MFN 12-040

Subject: NRC Requests for Additional Information Related to the Audit of the Economic Simplified Boiling Water Reactor (ESBWR) Steam Dryer Design Methodology Supporting Chapter 3 of the ESBWR Design Control Document – Draft Versions

Draft Responses for RAI 3.9-274 and 3.9-277

NRC RAI 3.9-277

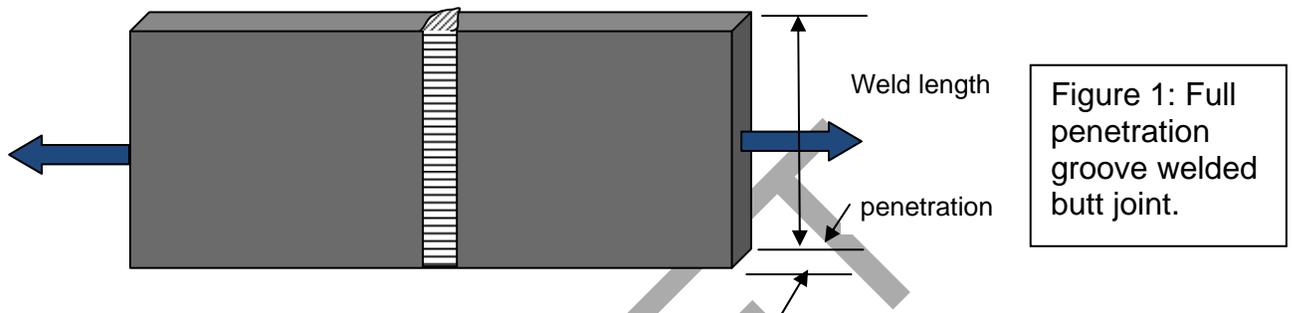
GEH is requested to discuss the use of specific types of welds in the ESBWR steam dryer and the justification for fatigue and quality factors for each weld type. In addition, GEH is requested to discuss the [] in the ESBWR steam dryer as described in NEDE 33313P, Rev 2. During the audit, the staff asked GEH to address the [] in the ESBWR steam dryer design, and how the [] will be conducted. At the audit, GEH made a definitive statement that the ESBWR steam dryer design []. The staff noted that this is inconsistent with NEDE 33313P, Rev 2. Please provide clarification if [] in the ESBWR steam dryer.

In summary, the welds used in ESBWR steam dryer design are full penetration groove welded butt joints, and [redacted]

In RAI 3.9-214, the fillet weld was []. The effective weld area is based on the effective throat or joint penetration times the effective weld length. For full penetration, the joint penetration is the thickness of the thinner member being joined (see figure 1).
